PRODUCT CHANGE NOTICE PCN Form (D4-E000-73)

EOL/PCN#22-007

REPLACEMENT PART REFERENCE GUIDE, RBP-650+

AN-75-026

MECHANICAL DIMENSIONS

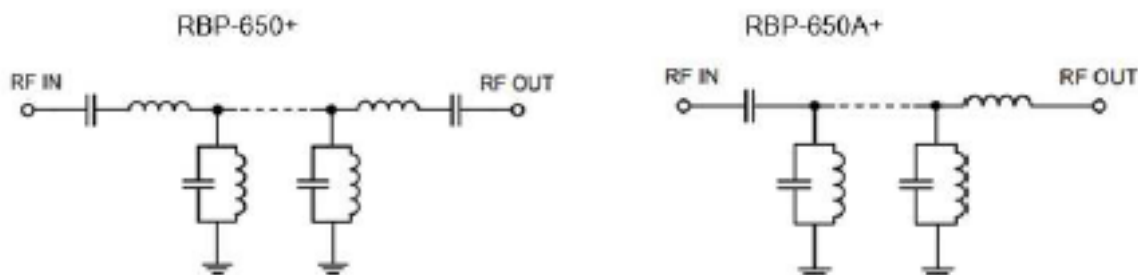
Case Style: GP731
Replacement part uses same case style as original part.

3) TYPICAL PERFORMANCE GRAPHS AT ROOM TEMPERATURE:

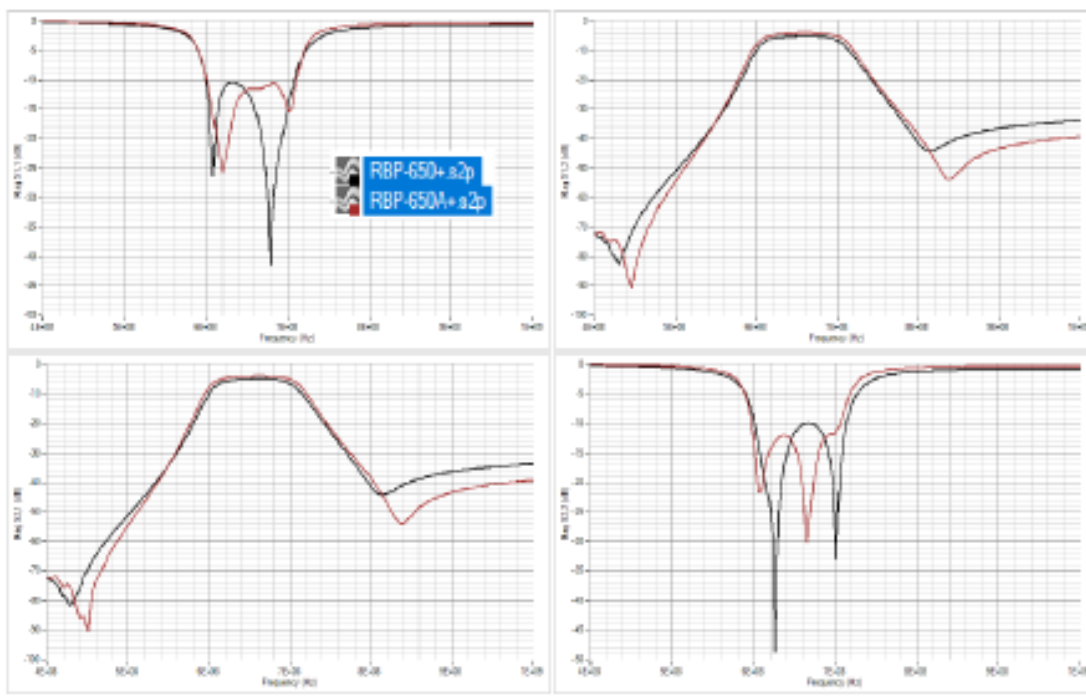
There is minor change in Function (Performance) due to change in functional schematic.

Original Part: RBP-650+

Replacement Part: RBP-650A+
